Arlington High School Building Committee

Meeting Materials Package – 5/3/2022

Change Order (CO)

Items included in this Change Order:	Cost:
CR 093.1 RFI 216.2 Provide Fire-rated ceiling at Stair 1 for elec conduit.	\$ 4,348.03
CR 189R1 ASI-112-112.1 Misc steel and conc changes Bldg B.	\$ 8,833.05
CR 203R2 ASI-121 Chase wall revisions abutting locker pods Bldg B.	\$ 35,810.78
CR 222 ASI-137-137.1RCP Revs- added GWB soffit at Part E.	\$ 2,045.99
CR 266 CCD-031-ASI-163 provide Spandrel glass in lieu of clear at CW52.	\$ 4,337.64
CR 291 ASI-176 Plywd barrier at catwalk gap between perimeter wall.	\$ 7,408.41
CR 292 ASI-180 Provide milwrk cover of steel box-beam at Aud. Balcony.	\$ 4,903.99
CR 302 Provide steel angle for CW doors/sidelights support at foundation.	\$ 6,435.28
CR 306 Rev to ceiling at Guidance area- added ceiling trim-soffit condition	\$ 3,752.54
CR 320 RFI-392 Rev GWB condition at CW49 for modified CW to wall relationship.	\$ 3,613.26
CR 323.1 RFI-582 Provide Boiler EPO Switches PH 2 areas.	\$ 3,712.59

REF. DWG. E2.0b RFI-582

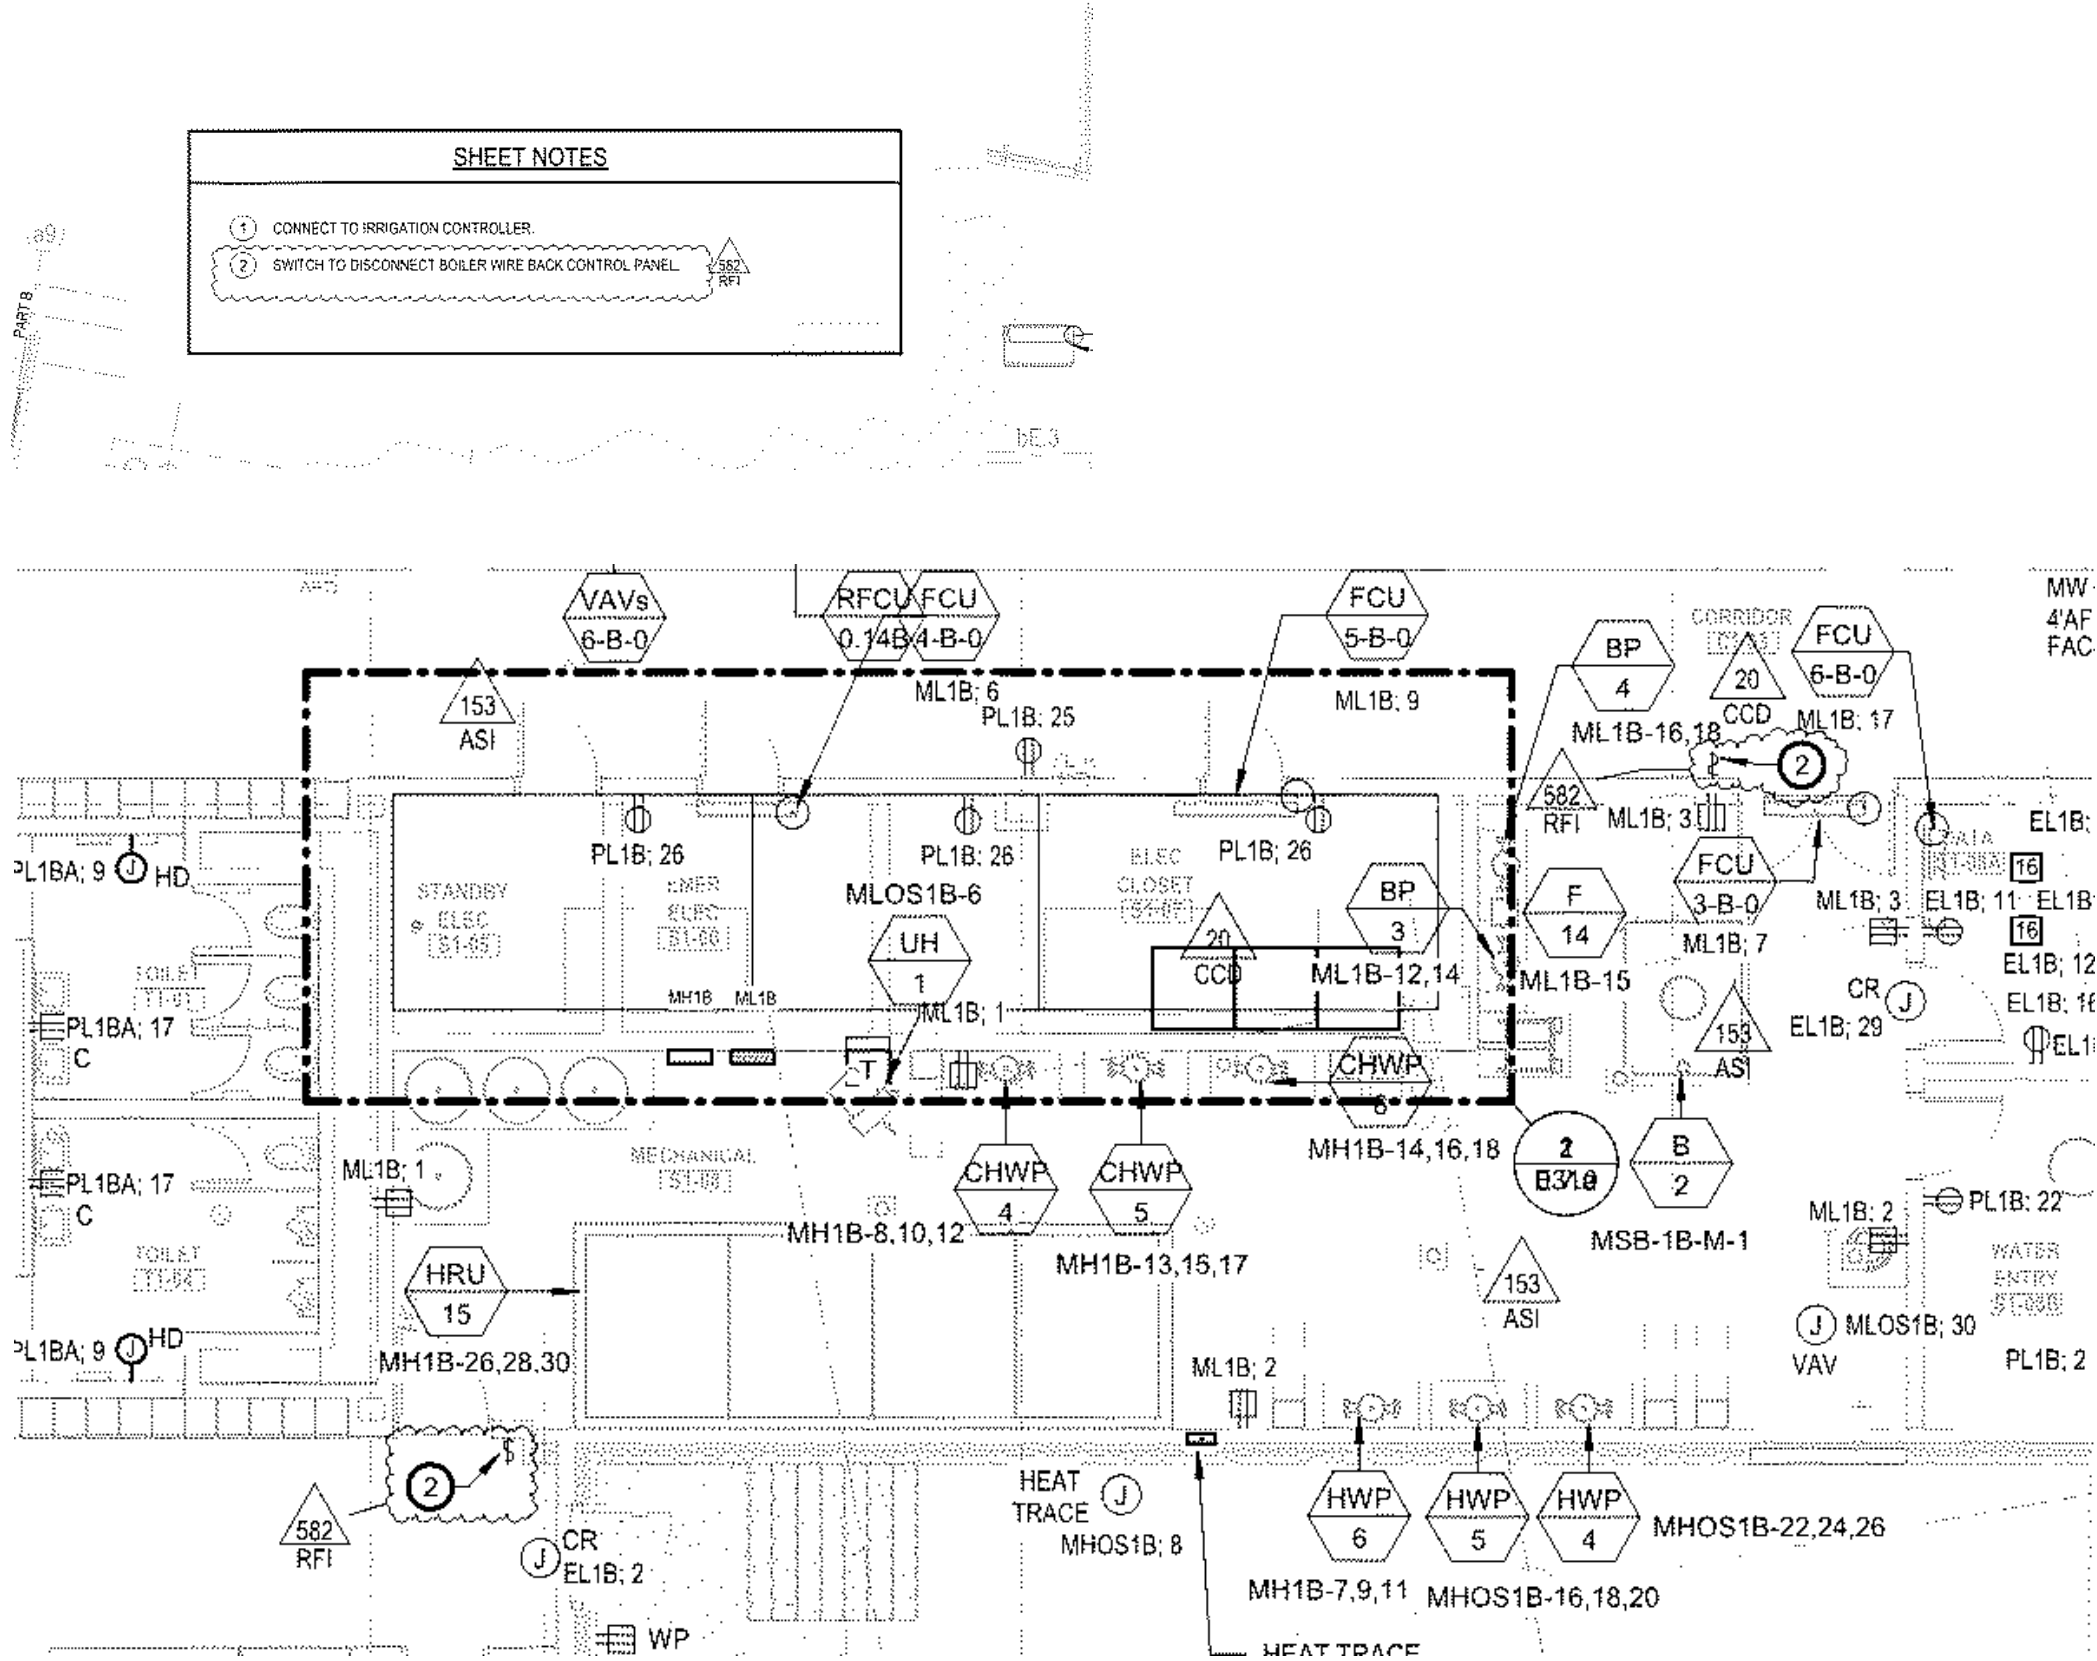
Emergency Disconnect Switches for Electric Boilers are required and should be added at both Mechanical Rooms. Refer to attached Sketches SKE-41A & 41B. Switches shall be push button type with "Emergency Boiler Shut-Down" text on device (by Pilla Electrical Model BSD120 or equal) installed in approximate locating shown at an elevation of 48" above finished floor. Switches located in common corridors shall be provided with tamper-proof plastic transparent covers.

CW08A & CW46 Sill Anchor Revision:

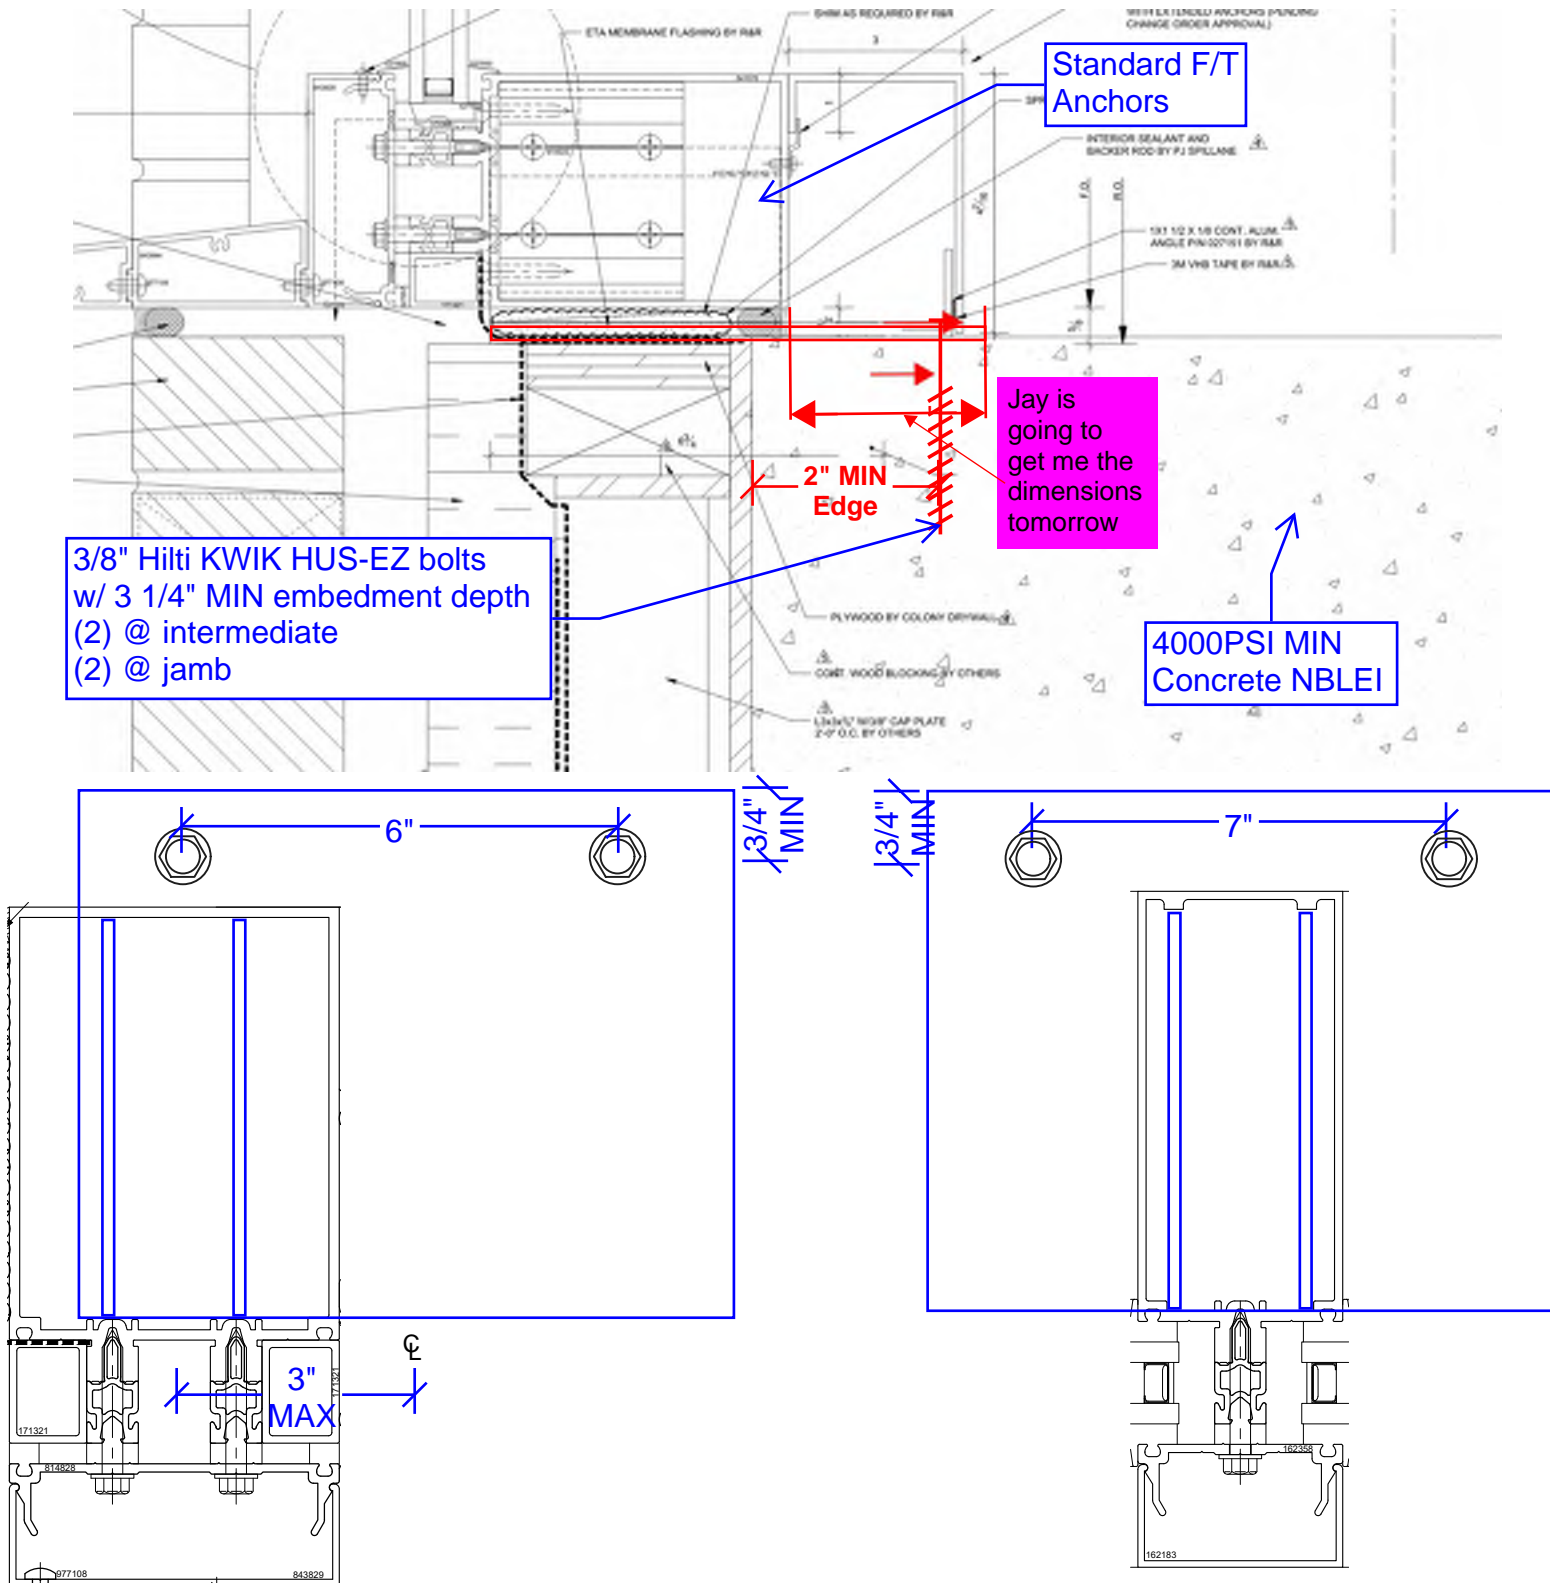
As detail 11/A7.2.7 didn't capture this condition (also not captured in the shop drawing process), any costs to accommodate this change in connection will be added scope to R&R.
